Repvblik is pleased to present our updated plans for the conversion of the existing Madison Plaza Hotel at 3841 E Washington Avenue into multifamily apartments for final approval with the Urban Design Commission.

Initial Approval: September 7th, 2022

Commission Feedback & Repvblik Response:

RENOVATION
PLATO'S MADISON, WI
3841 E WASHINGTON AVE, MADISON, WI 53714

GUTTERS / DOWNSPOUTS (TYPICAL)

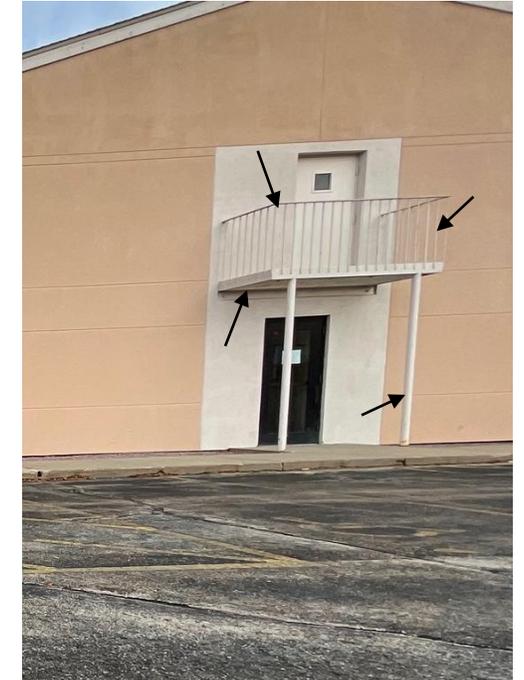
- a. *An updated photometric plan is attached herein.*
3. The applicant shall update the elevations to address architectural comments, including:
 - a. Updating the color of the downspouts and gutters to match the exterior wall color,

- i. *Downspout and gutter colors have been revised to match the surrounding façade.*
 - b. Consideration should be given to downplaying the arches in the building gable ends,

GUTTERS: EPT-2a, TYP
DOWNSPOUTS: EPT-1a, TYP
